Service Bulletin

21-009

June 8, 2021 Version 5

Safety Recall: 2009-13 Fit Driveshaft Inspection

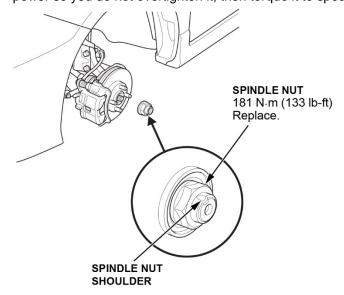
Under REPAIR PROCEDURE step 19, a note and images were added.

NOTE: It is important to know that many air and battery powered impact guns can achieve 2 or 3 times the axle nuts torque specification. If you severely over-torque an axle nut, it is possible to break a driveshaft as shown below:

NOTE: If you are going to use an air or battery powered impact gun to install the nut, make sure to turn down the air or power so you do not overtighten it, then torque it to specification using a torque wrench.
